Office Action Summary	Application No. 10/599,970	Applicant(s) SAWAMURA ET AL.	
	Examiner Khanh Dang	Art Unit 2111

DETAILED ACTION

Fig. 3
Prior Art

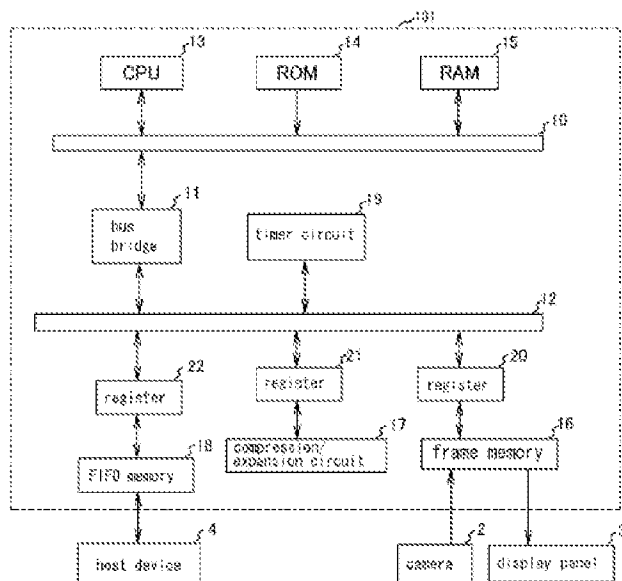
The APA, in Fig. 3, which is reproduced below for ease of reference and convenience, discloses an image processing device comprising: a high-speed bus (10) and a peripheral bus (12) linked via a bus bridge (11); a CPU (13) arranged to carry out

computations and control of image processing; a data transceiving FIFO memory (18) arranged to carry out transceiving of image compression data with a host device (4); a frame memory (16) arranged to store image expansion data and to display the data on a display panel (3); and a compression/expansion circuit (17) arranged to carry out compression of image expansion data and expansion of image compression data; wherein the CPU (13) is connected to the high-speed bus (10), and the data transceiving FIFO memory (18) is connected to the peripheral bus (12). See also paragraphs [0003] to [0004] of the specification.

The APA does not disclose that the frame memory (16) is connected to the high-speed bus (10).

It would have been obvious to one of ordinary skill in the art at the time the invention was made to connect the frame memory 16 to the high speed bus 10, as taught by Kopet, for the purpose of providing higher bus speed for image processing.

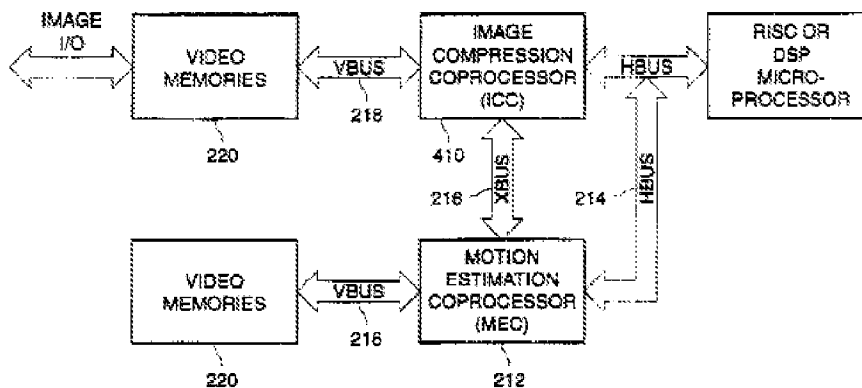
However, connecting a frame memory to a high speed bus is old and well-known as evidenced by at least Kopet. Kopet, in Fig. 2, which is reproduced below, discloses

an image processing apparatus, wherein the frame memory or video memories 220 is connected to a host bus or high speed bus HBUS via the VBUS 218 and MEC 212 (note that the MEC is not required for applications that do not need motion compensated frame encoding) for the purpose of providing higher bus speed for image processing. See column 4, line 58 to column 5, line 25.

With regard to claim 6, Kopet also discloses that the compression and decompression circuit 410 is connected to the host bus or high speed bus HBUS. Thus, it would also have been obvious to one of ordinary skill in the art at the time the invention was made to connect the compression/expansion circuit 17 to the high speed bus 10, as taught by Kopet, for the purpose of providing higher bus speed for image processing.
